COMMITTEE OF THE WHOLE AUGUST 20, 2001

**SITE DEVELOPMENT APPLICATION
YORK REGION DISTRICT SCHOOL BOARD
RUTHERFORD ROAD/ISLINGTON AVENUE SECONDARY SCHOOL
FILE: DA.01.044**

ATTACHMENT "2"
SITE PLAN

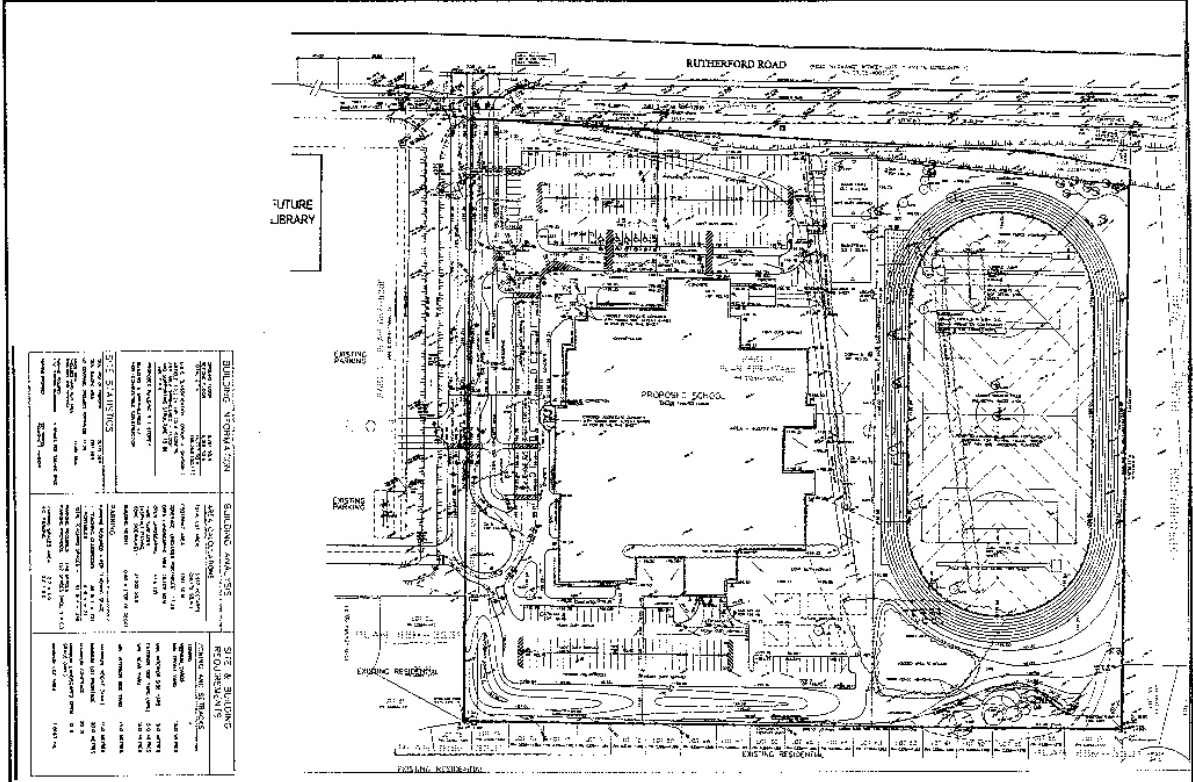
Vehicular access to the site is provided by a shared, signalized full movement driveway consisting of a right-in lane and right-out and left-out lanes. The access is to be shared between the proposed school site and a future City library. The access travels southbound to a turning circle, connecting to a parking area and to a separate City-owned driveway along the property line of the existing community center, which exits to Islington Avenue. The appropriate traffic recommendations, such signage and traffic calming measures, will be implemented through the circulation process. The final site plan and traffic study must be reviewed by the City Transportation department.

Two parking areas are proposed for the site; one north of the school fronting onto Rutherford Road and the second south of the school. A total of 266 parking spaces have been provided for the site, which is in excess of what is required by the Zoning By-law. Lay-by parking has been provided along the main driveway and the main entrance to the school.

Staff have reviewed the proposed site plan application for a secondary school. The plan as submitted, would require exceptions for access and related agreements between the School Board and the City of Vaughan. Prior to the issuance of a building permit, the final elevations and landscape plan and cost estimate must be reviewed by City Staff.

1. That prior to the issuance of a building permit:
 - a) the final site plan and elevations shall comply with the Zoning By-law and shall be to the satisfaction of the Community Planning, Urban Design and Building Standards Departments;
 - b) the final grading and drainage plans, storm water management report, servicing report and traffic study shall be to the satisfaction of the Engineering Department;
 - c) the landscaping plan cost estimate and tree inventory plan shall be to the satisfaction of the Urban Design Department;
 - d) all the necessary easements and right-of-ways be granted; and
 - e) the Applicant conduct additional investigation work to confirm that no evident or residual soil or groundwater contamination issues exist to the satisfaction of the City.

ATTACHMENT "3" LANDSCAPE PLAN	FILE #:	REPORT #:	DATE: 05/06/2001
	Z.01.044	LOCATION: LOT 15, CONC.7	SCALE: NOT TO SCALE
CITY OF VAUGHAN PLANNING DEPARTMENT		APPLICANT: YORK REGIONAL DISTRICT SCHOOL BOARD

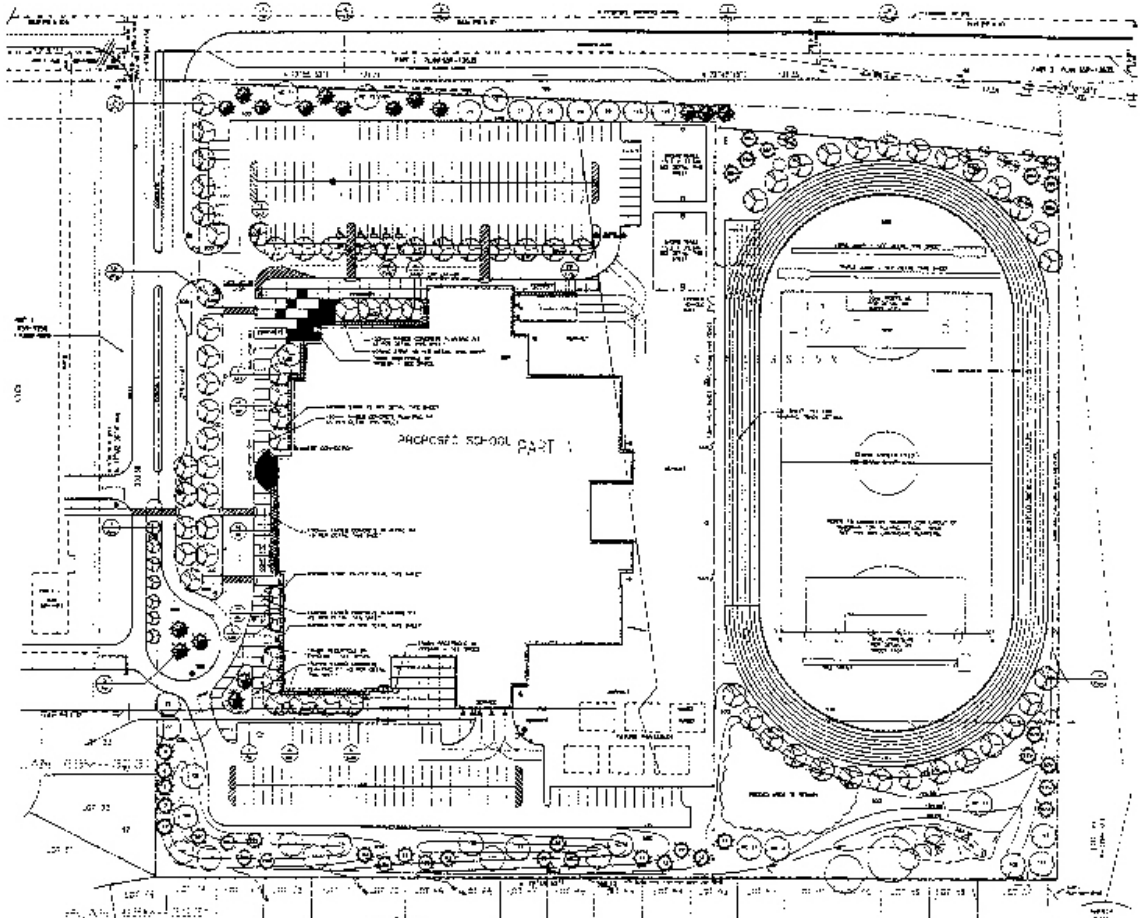
The proposed school site is located adjacent to the Humber Valley corridor and all existing trees, shall be maintained or relocated, specifically along the abutting residential subdivision to the south. Landscaping consisting largely of a variety of deciduous and coniferous trees, is proposed along the periphery of the site and the school building itself. A row of deciduous trees is located along the main driveway from Rutherford Road providing separation between the incoming and outgoing traffic.

An extensive 15m landscape strip and berm is proposed along the south portion of the site which provides sufficient screening to the neighbouring residential community. A wood lot located at the eastern portion of the site will remain and be incorporated within the landscaping scheme. The

The Applicant must provide a tree inventory plan indicating the trees to be saved and moved to the satisfaction of the Urban Design Department.

The Applicant has indicated that the portion of the site comprising the basketball courts, soccer field and running track will be opened to the public, but lighting will not be provided. The residents of the adjacent residential subdivision have expressed concerns with respect to lighting. Staff has a concern that a lack of lighting during those periods of the year when daylight is shortened, will leave an area that could be unsafe and difficult to patrol. The Urban Design Department will review and approve the final landscape plan, including the need for lighting plan, and a cost estimate.
